WORKSHOP AGENDA

Planning Commission

October 14, 2025 @ 5:30 PM

Item #: 3. Site Plan - Dous Retail Center - Building totaling 4,200 Square Feet on 1.28 Acres. Requested by Chet Rhodes. Property located at 5130 Murfreesboro Road (Tax Map 15M, Group A, Parcel 1). C-2 (Highway Service) Zoning District. Property owned by TN Group Properties, LLC.

PROJECT NO. 1574-01	
SEPTEMBER DATE: 2025	DRAWN BY: HLP
	CHECKED BY: RWM
SCALE: 1"=30'	APPROVED BY: RWM
SHEET NO. C6.01

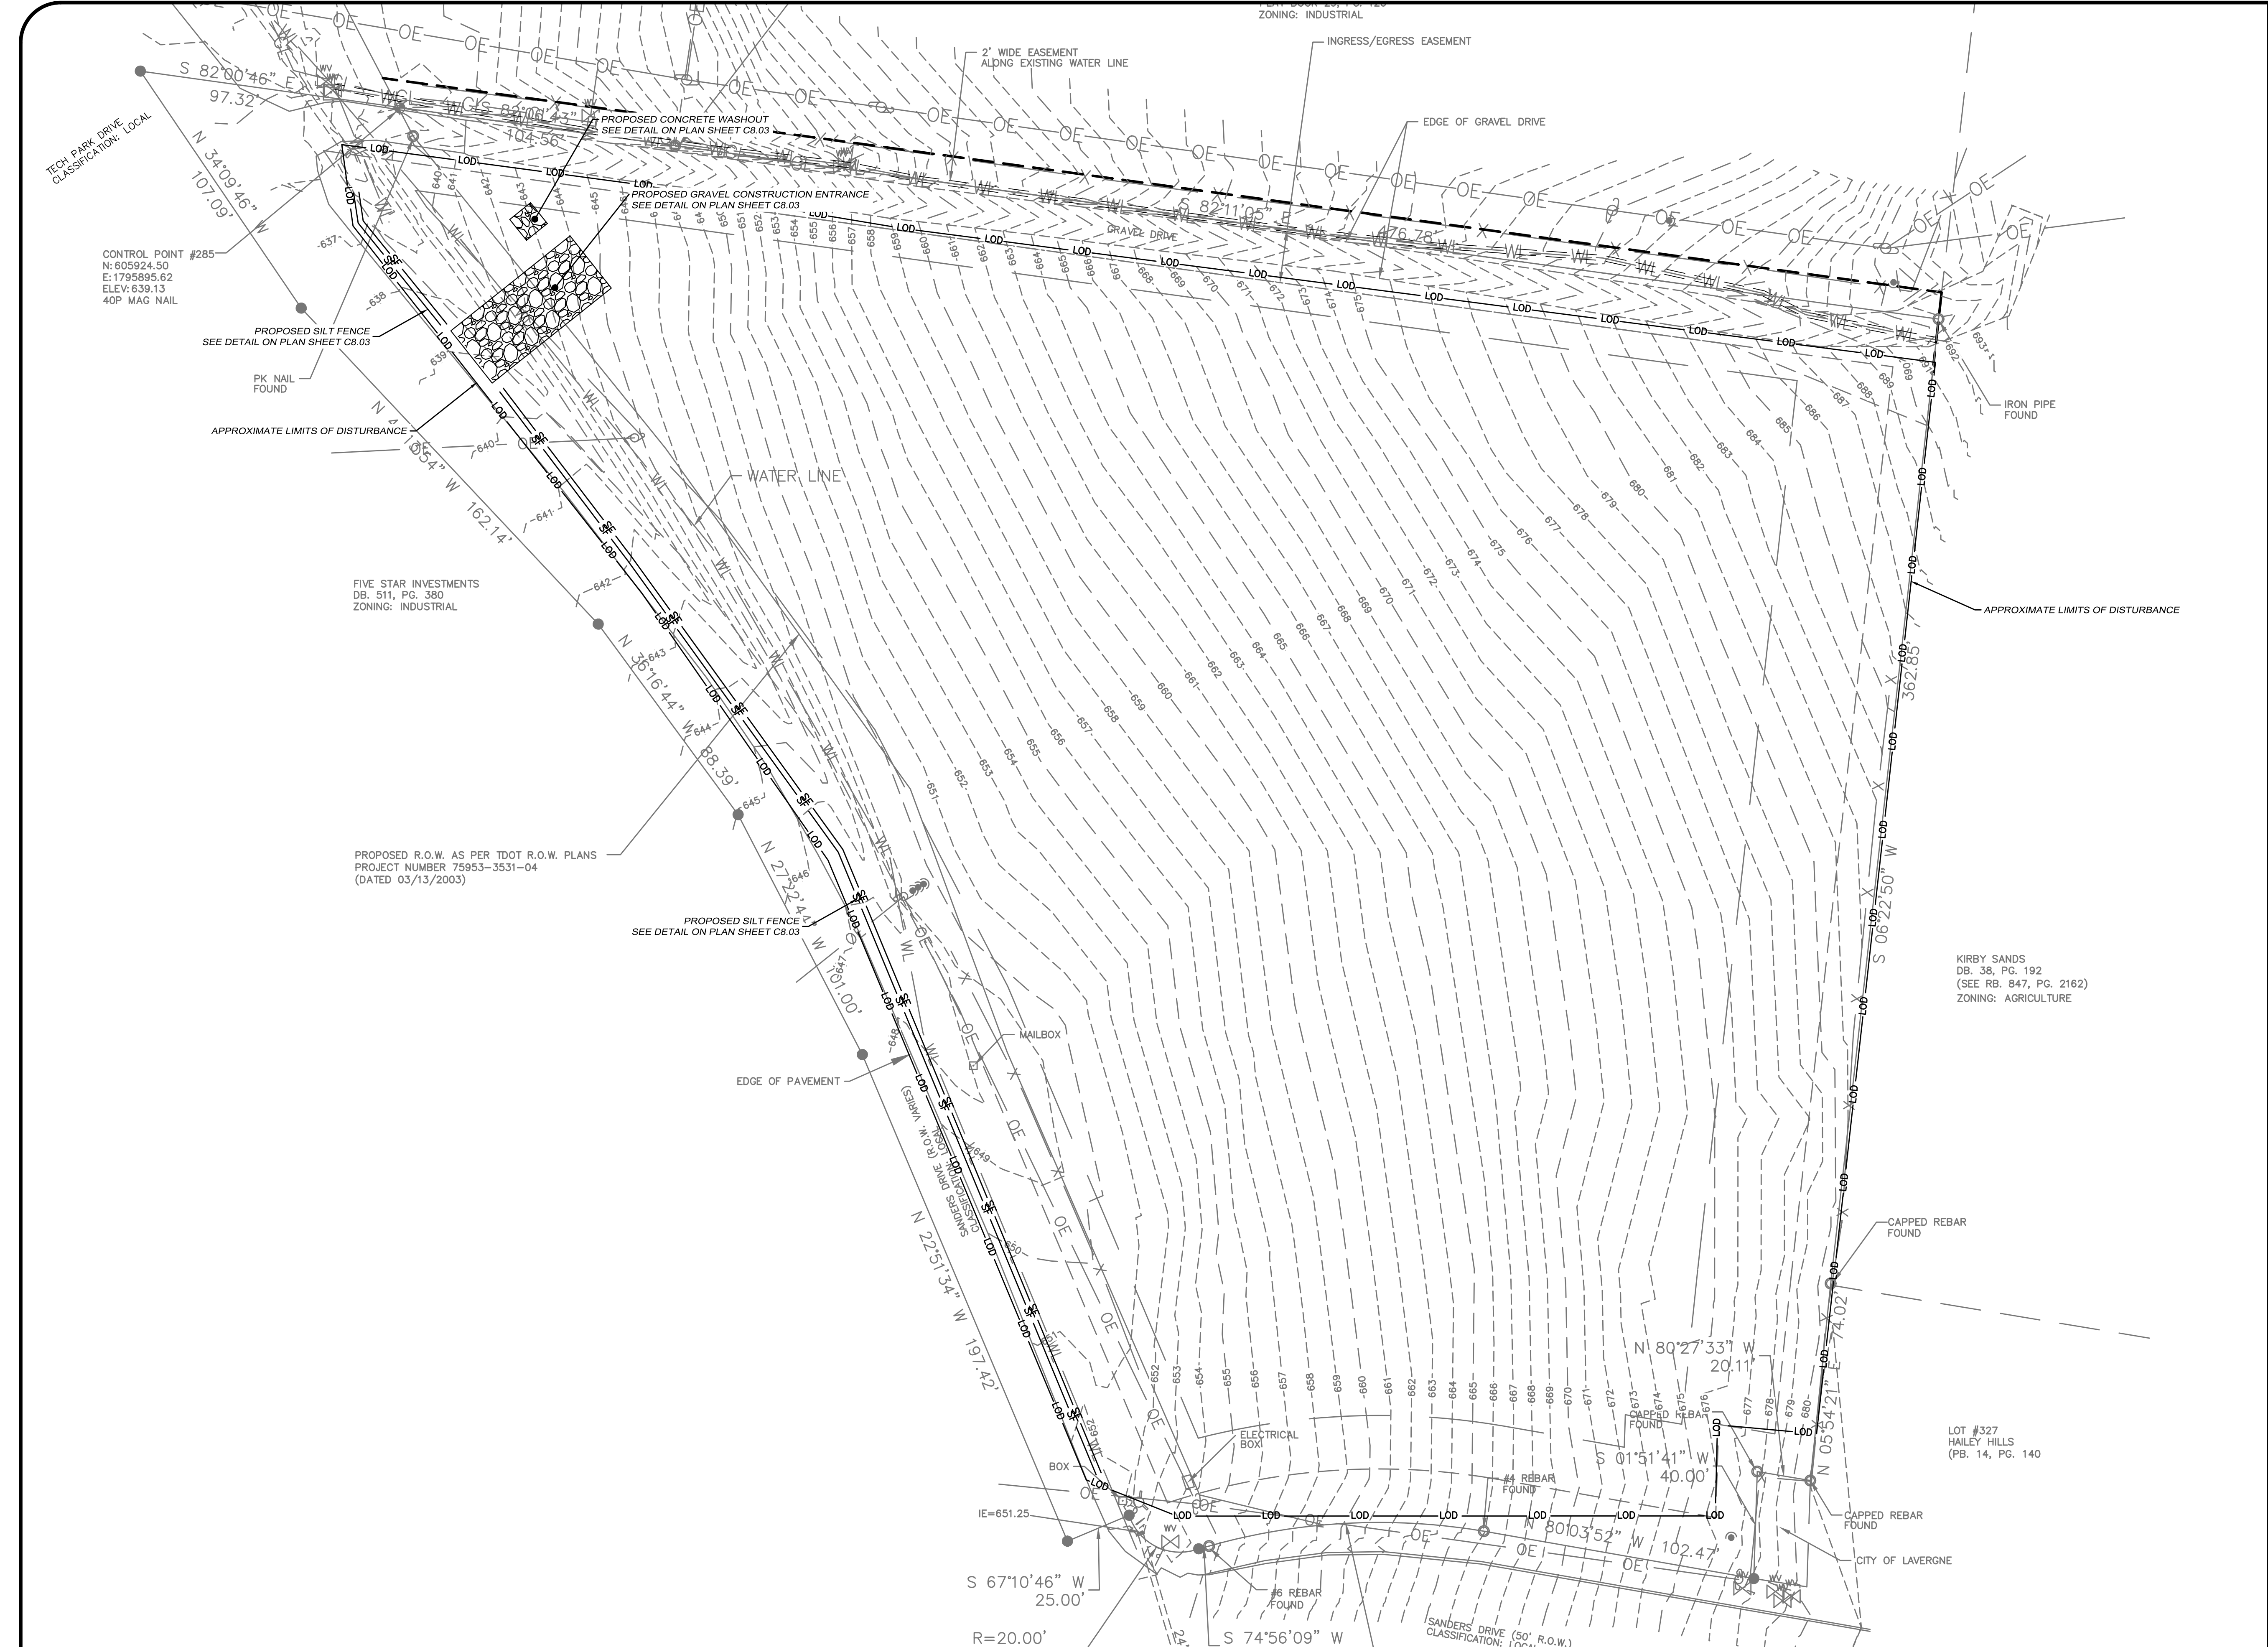
30. (Sheet C6.01, C6.02) Correct Silt Fence, Concrete Wash-out, and Construction Entrance references (the sheet reference is incorrect)
31. (Sheet C6.01) Show construction entrance graphically at 100 feet long.

34. (Sheet C6.01) Extend silt fence 100 feet in both directions
35. (Sheet C6.02) There is no Erosion Control Matting detail found on Sheet C6.04. Provide detail or change note.

39. (Sheet C6.02) This plan needs to show the grading necessary for the sediment ponds to comply with Item 38 above.
40. (Sheet C6.01) Show inlet protection at the existing culvert under the existing access drive along the north boundary.
